# Wisconsin Department of Transportation

**Proposal #30: 1517-75-72, WISC 2017 345**  
**USH 10 – USH 10/STH 441**  
**County CB – Oneida St**  
**Midway Interchange Mainline**  
**USH 10**  
**Winnebago County**

### Letting of June 13, 2017

This is Addendum No. 02, which provides for the following:

SUPERSTRUCTURE DETAILS  
 SHEET 16  
 465

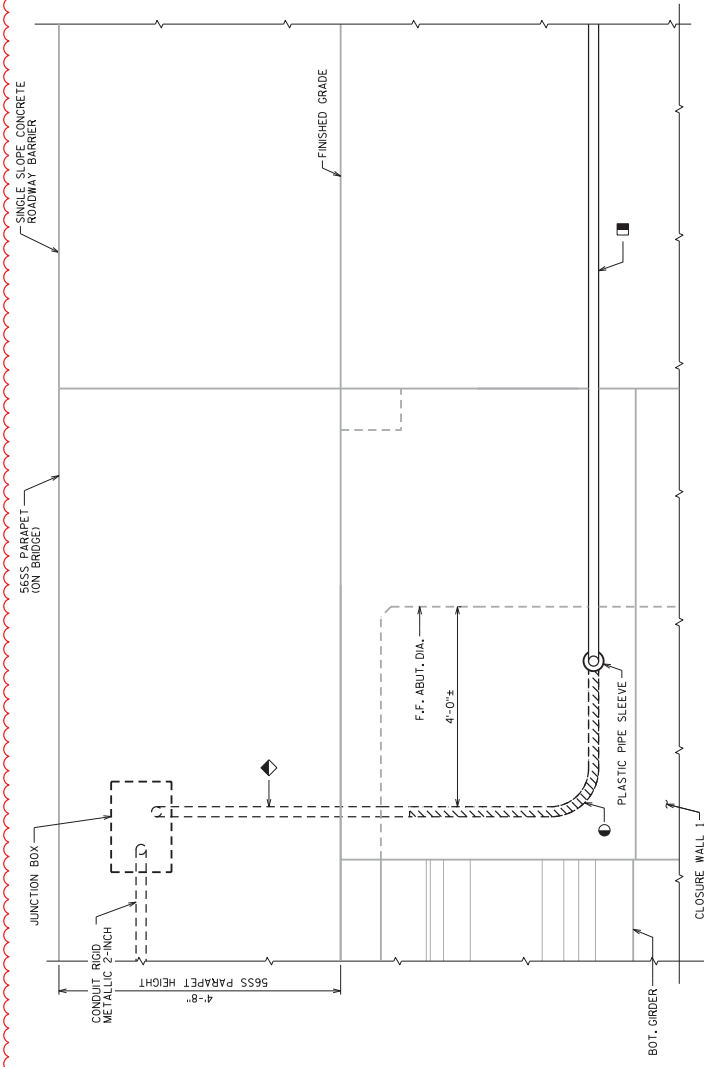
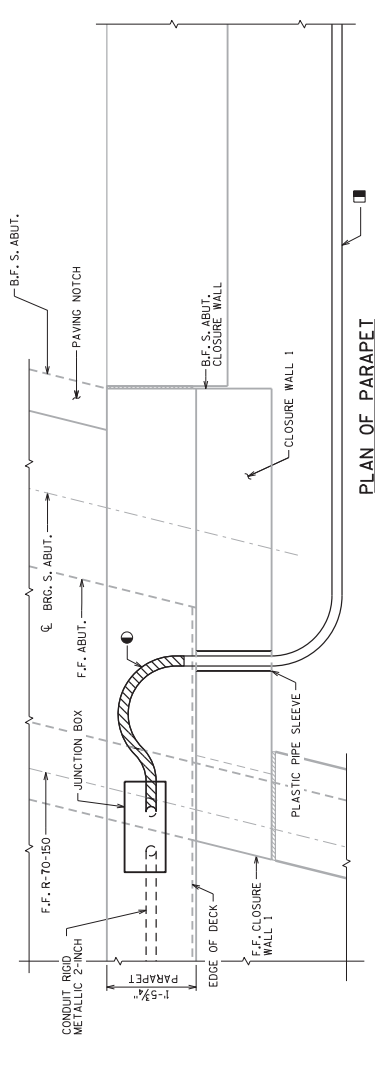
(1) JUNCTION BOXES AT N. ABUT. & PIER AND S. ABUT. SEE ELECTRICAL DETAILS SHEETS.  
 (2) CONDUIT RIGID METALLIC 2-INCH. SEE ELECTRICAL DETAILS SHEETS.  
 (3) CONDUIT RIGID METALLIC 2-INCH. SEE ELECTRICAL DETAILS SHEETS.

NO.	DATE	ADDED ELECTRICAL DET. SHEET REVISION	EMK	BY
5/17

ELECTRICAL DETAILS

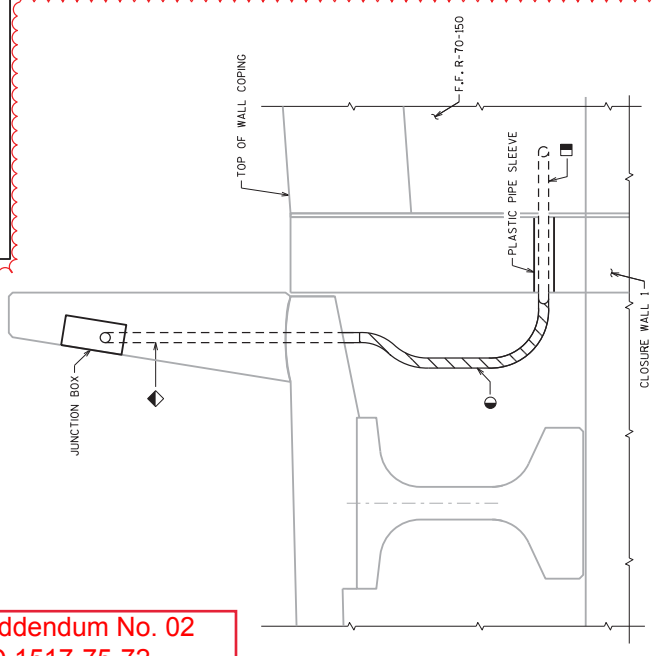
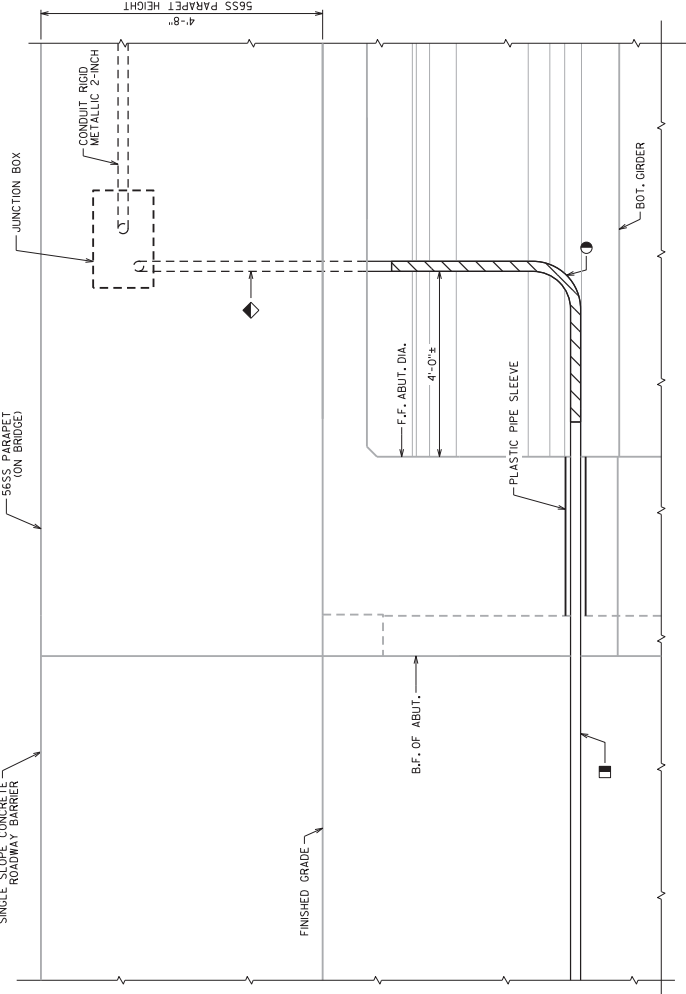
- CONDUIT RIGID NONMETALLIC SCHEDULE 80 2-INCH TO FIRST LIGHT POLE JUNCTION BOX, AND INSTALLED 4'-0" THROUGH CLOSURE WALL 1
- ◀ CONDUIT RIGID NONMETALLIC SCHEDULE 80 2-INCH STUBBED 4'-0" BELOW DECK
- CONDUIT NON-METALLIC LIQUID TIGHT 2-INCH

NO.	DATE	REVISION	BY
1	5/17	ADDED ELECTRICAL DET. SHEET	EMK

BID ITEMS SHALL BE:  
 "CONDUIT RIGID NONMETALLIC SCHEDULE 80 2-INCH"  
 "JUNCTION BOXES 18X12X6-INCH, EACH  
 APPROVED MANUFACTURERS - JUNCTION BOXES:  
 SEE APPROVED MATERIAL LIST.  
 LIQUID TIGHT FLEXIBLE CONDUIT, ANGLES AND ADAPTER FITTINGS  
 TO BE INCIDENTAL TO "CONDUIT RIGID NONMETALLIC SCHEDULE 80  
 2-INCH".  
 INSTALL GROUNDING BUSHINGS ON ALL RIGID METALLIC ELECTRICAL  
 CONDUITS THAT TERMINATE IN JUNCTION OR PULL BOXES.  
 WHEN CONNECTING ON METALLIC CONDUIT TO METALLIC CONDUIT,  
 ONLY ADAPTER FITTINGS ULL OR NRTL LISTED FOR ELECTRICAL  
 USE SHALL BE USED.  
 PLASTIC PIPE SLEEVE MUST BE AT LEAST TWICE THE O.D. TERMINAL  
 THAN THE O.D. OF THE CONDUIT TO BE SEALED.  
 AT F.F. AND B.F. WITH NON-BITUMINOUS JOINT SEALER. IT DEEP  
 AND HOLD 7/8" BELOW SURFACE OF CONCRETE TO BE INCIDENTAL  
 TO "CONDUIT RIGID NONMETALLIC SCHEDULE 80 2-INCH".

SHEET 19  
ELECTRICAL DETAILS 2  
466B

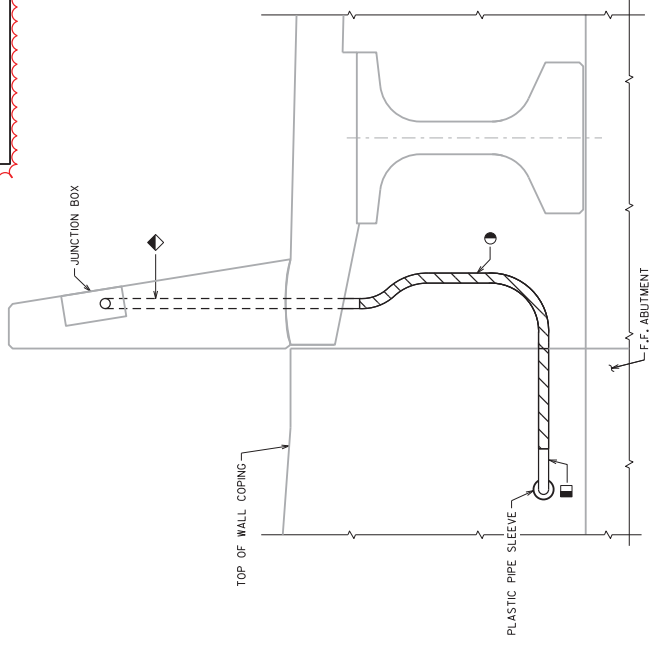
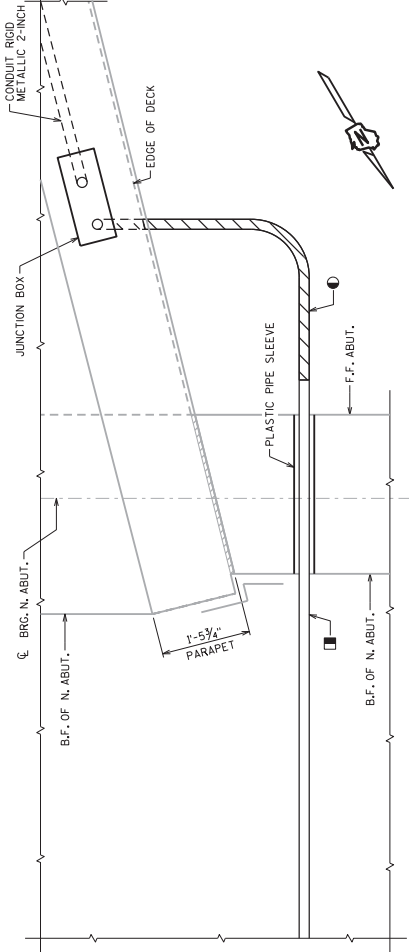
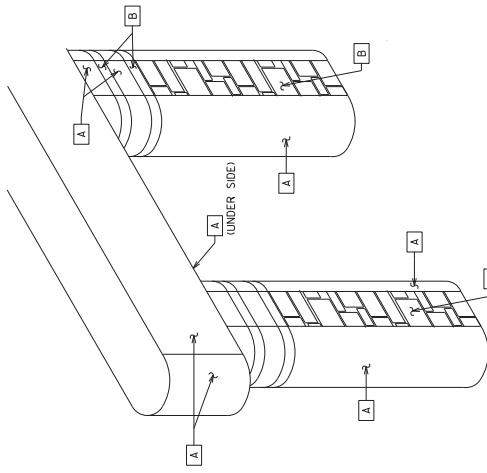
- CONDUIT RIGID NONMETALLIC SCHEDULE 80 2-INCH TO BE INSTALLED THROUGH ABUTMENT BODY AND INSTALLED 4"± THROUGH ABUTMENT BODY.
- ◀ CONDUIT RIGID NONMETALLIC SCHEDULE 80 2-INCH STUBBED 4"± BELOW DECK
- CONDUIT NON-METALLIC LIQUID TIGHT 2-INCH

NO.	DATE	REVISION	BY
1	5/17	ADDED ELECTRICAL DET. SHEET	EMK

**NOTES**  
BID ITEMS SHALL BE:  
-CONDUIT RIGID NONMETALLIC SCHEDULE 80 2-INCH"  
-JUNCTION BOXES 18X12X6-INCH, EACH APPROVED MANUFACTURERS - JUNCTION BOXES: SEE APPROVED MATERIAL LIST.  
LIQUID TIGHT FLEXIBLE CONDUIT, ANGLES AND ADAPTER FITTINGS TO BE INCIDENTAL TO "CONDUIT RIGID NONMETALLIC SCHEDULE 80 2-INCH".  
INSTALL GROUNDING BUSHINGS ON ALL RIGID METALLIC ELECTRICAL CONDUITS THAT TERMINATE IN JUNCTION OR PULL BOXES.  
WHEN CONNECTING ON METALLIC CONDUIT TO METALLIC CONDUIT, ONLY ADAPTER FITTINGS ULL OR NRTL LISTED FOR ELECTRICAL USE SHALL BE USED.  
PLASTIC PIPE SLEEVE MUST BE AT LEAST TWICE THE O.D. DIAMETER OF THE CONDUIT. SLEEVE TO BE FILLED WITH MATERIAL THAT MEETS ALL REQUIREMENTS FOR CONDUIT SLEEVE. SLEEVE TO BE 1" LONG B.F. OF NORTH ABUTMENT. CONDUIT SLEEVE TO BE 1" LONG AND HOLD 1/8" BELOW SURFACE OF CONCRETE. TO BE INCIDENTAL TO "CONDUIT RIGID NONMETALLIC SCHEDULE 80 2-INCH".
